URBAN DESIGN COMMISSION APPLICATION CITY OF MADISON

1. Project Address: 425 W. WASHINGTON AVE.
 Project Title (if any): WASHINGTON PLAZA

Major Alteration Submission - THE **Washington Plaza**
residential

ADDENDUM to Letter of Intent dated March 23, 2016

| Site Plan Changes | |

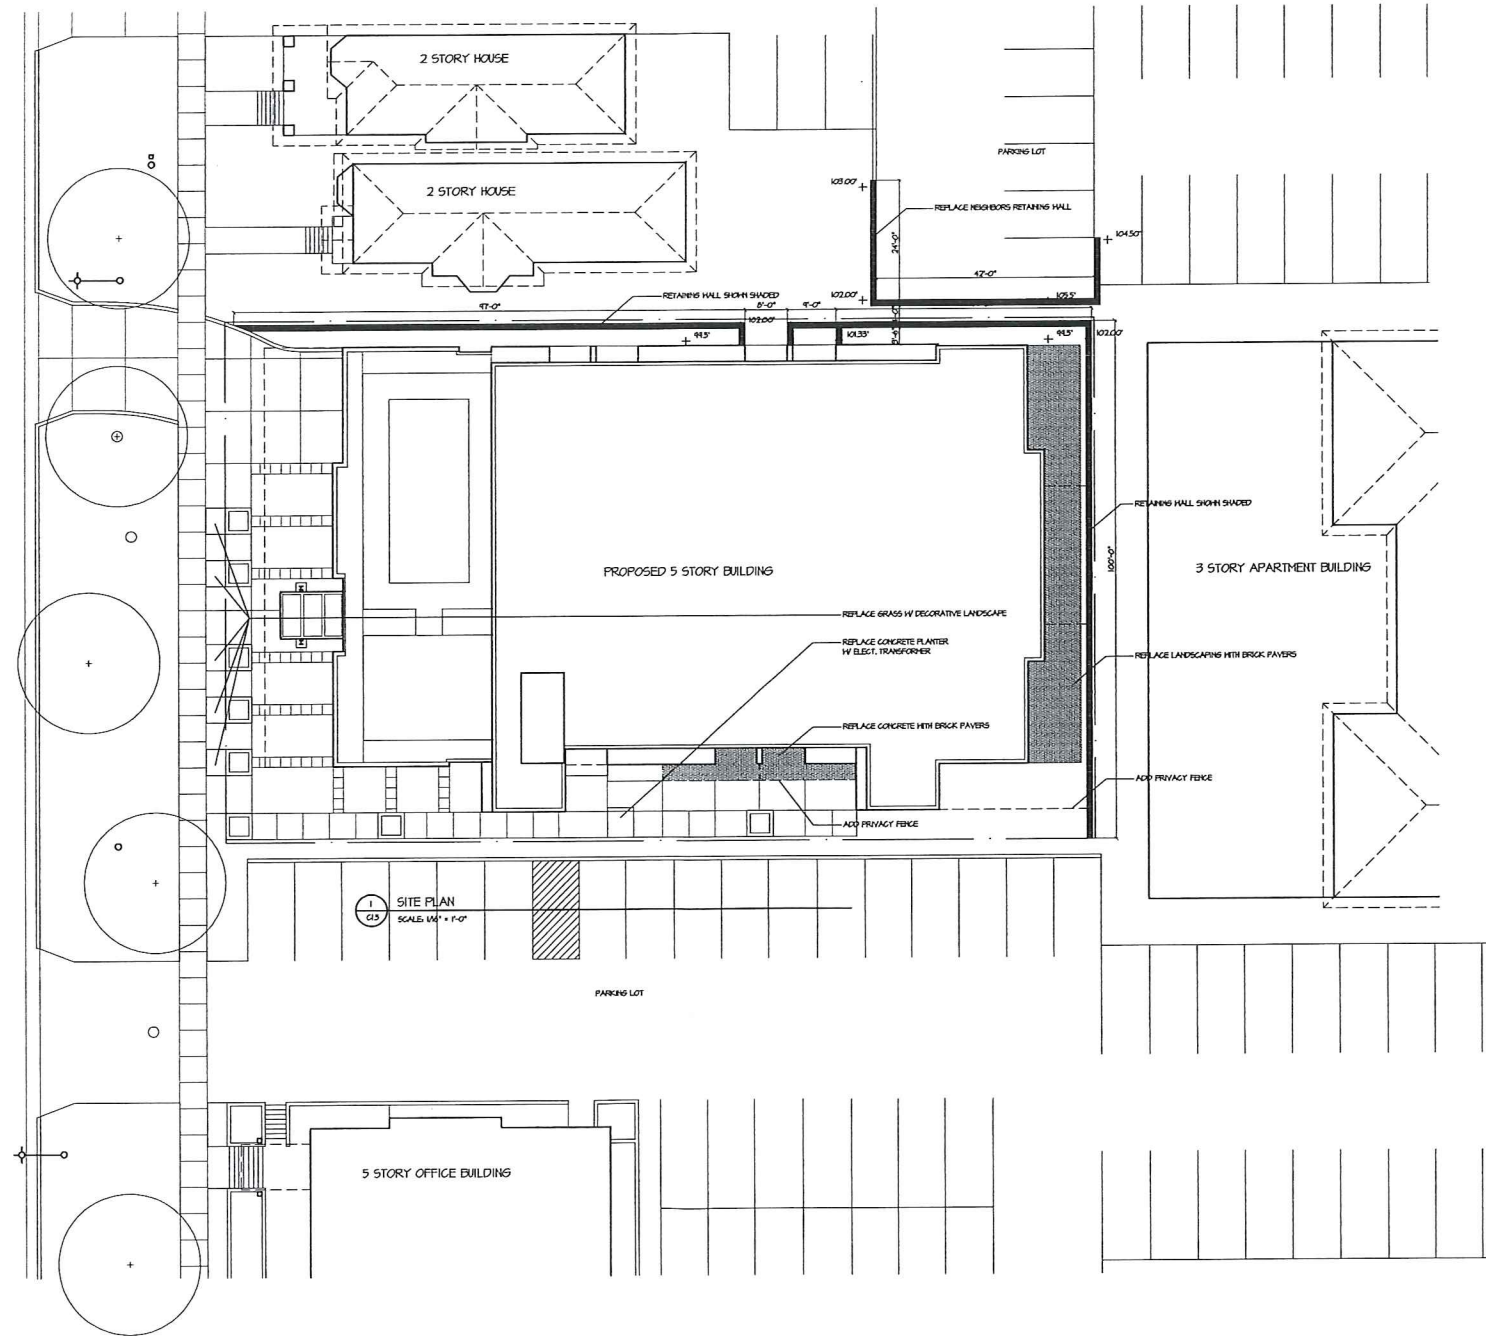
- 1A Railing installed according to Fire Department direction.
- 1B Additional equipment for back-up generator required by code.
- 1C Building code limitation on openings allowed per floor.
- 1D Fire Department required hose connection.

- ~~2A* Apartment HVAC vents did not fit in allowed width and had to be relocated. * *~~
- 2B Additional HVAC was required for commercial space.
- 2C Intake and exhaust required for design.
- 2D Dryer vents located where structure allowed access.
- 2E Security cameras.
- 2F MG&E required location for transformer replaced one planter.

- 3A 6 foot wood fence for ground floor apartments to screen lights from adjacent parking lots and provide security due to lower elevation.
- 3B Remove ground cover plantings and replace with pavers for tenant use of apartments on ground floor.
- 3C Add metal angles to protect masonry at garage entrance in place of raised curb.
- 3D Replace and add masonry retaining wall to improve site drainage.

3
A2.1
FENCE DETAIL
SCALE 1/2" = 1'-0"

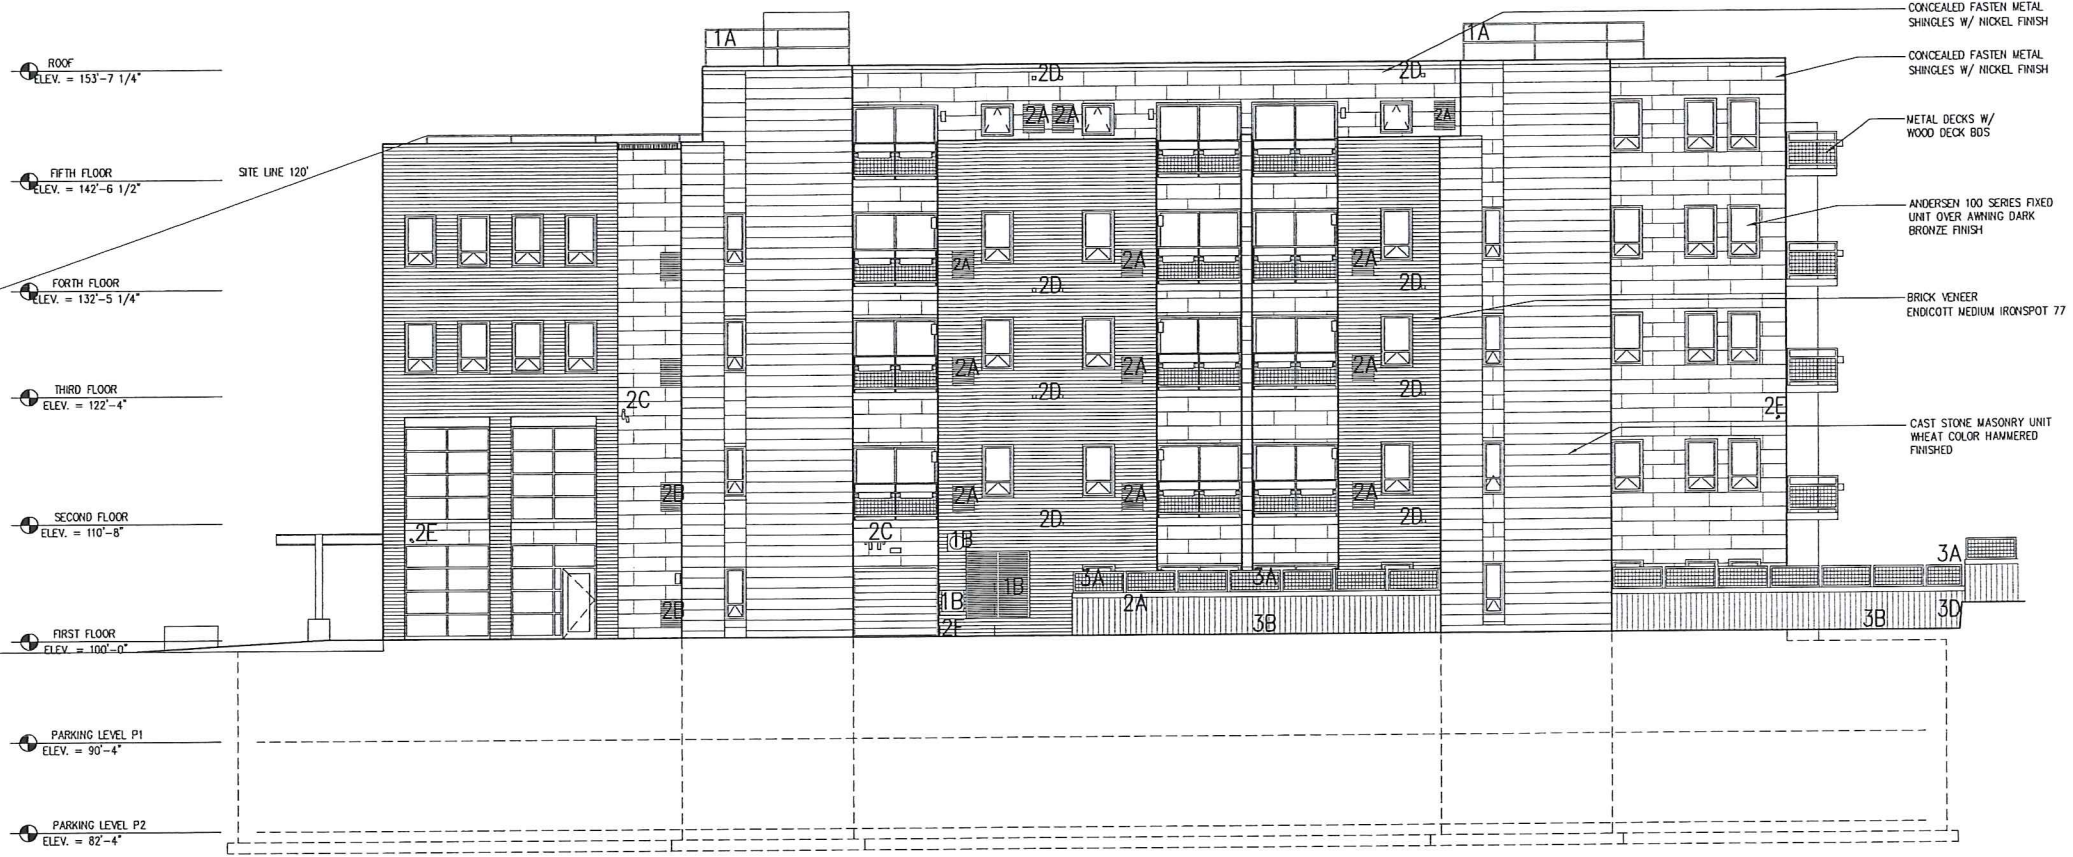
At UDC June 1, 2016, we were asked to provide more details regarding fencing changes. With this submission we have: Added detailed fence section and elevation with dimensions and notes.

Wood fence reduced to 4' height and stained dark bronze.

Add metal mesh module to the top of the wood fence matching the existing deck detail also in dark bronze.

1 ROOF TERRACE RAIL DETAIL - APPROVED
 A3.5 SCALE: 1 1/2" = 1'-0"

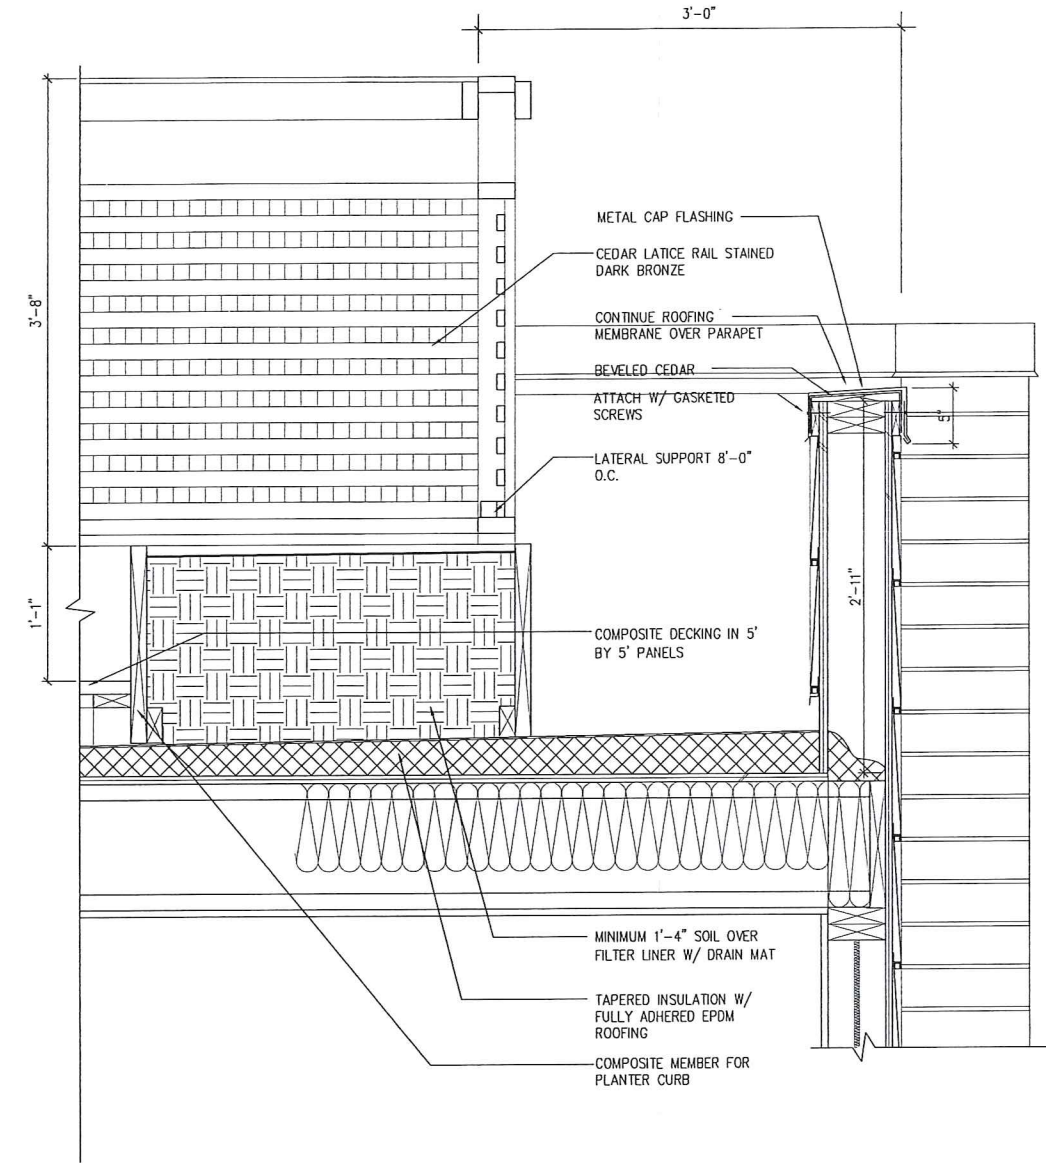
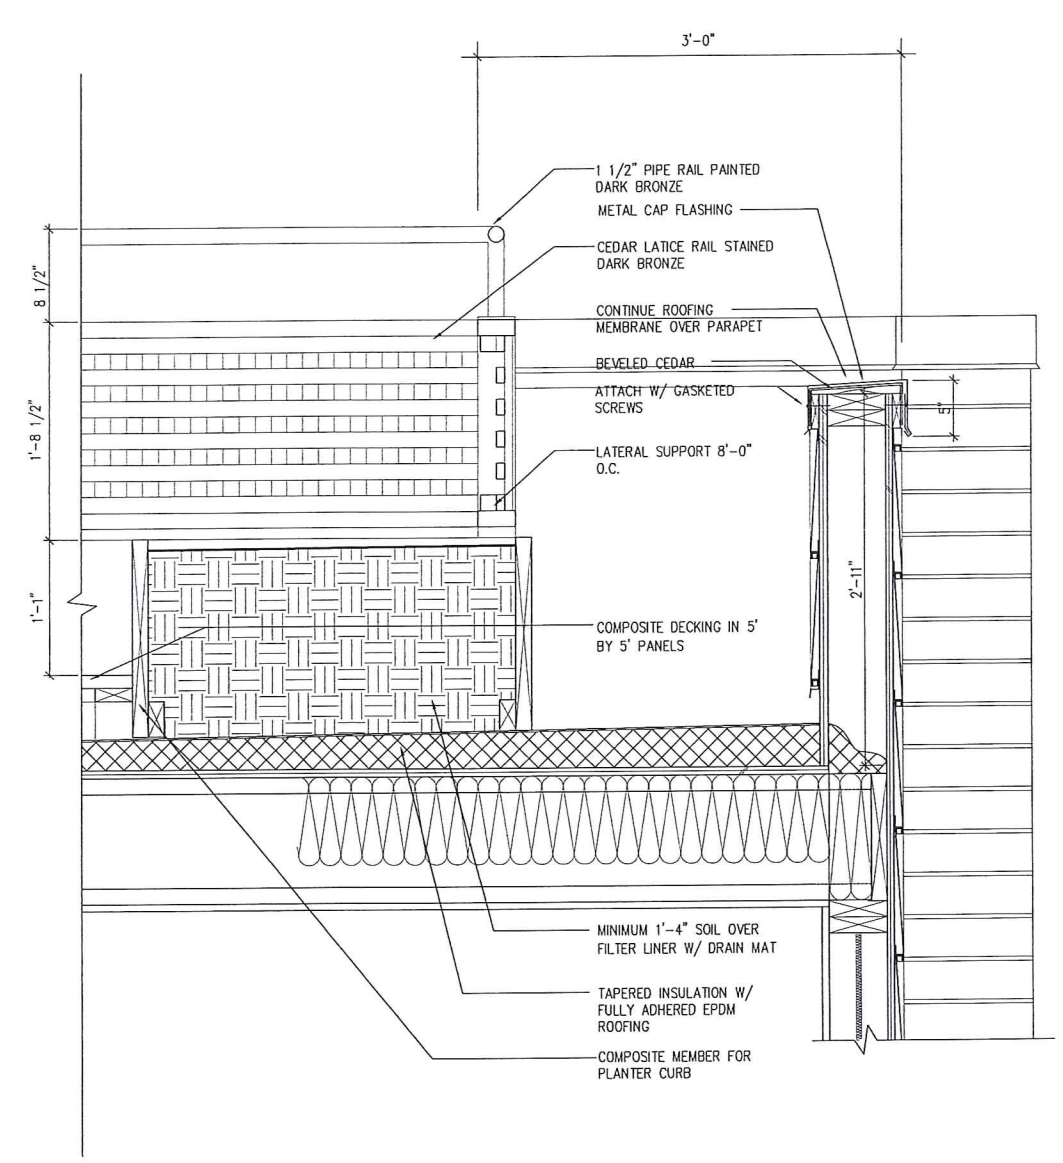
This is in response to the city staff requesting as built showing all components for the Washington Plaza project. As a result, we were asked to submit 4 items to be reviewed by UDC. First was a wooden trellis on the rooftop terrace. This will be removed instead. Second was the railing for the rooftop terrace as it was built higher than approved and in different material. It has been redesigned to be lowered to the original height with the top rail in metal and finish to match the approved design. Third was the modification of the landscape plan to replace concrete sidewalk and planting area with brick pavers for individual tenant patio areas. We verified that we did not exceed the 90% area covered. Fourth is the addition of privacy fencing not on the original submission. This has been redesigned to match architecture.

Included sight line for the top of rooftop garden rail from the street.
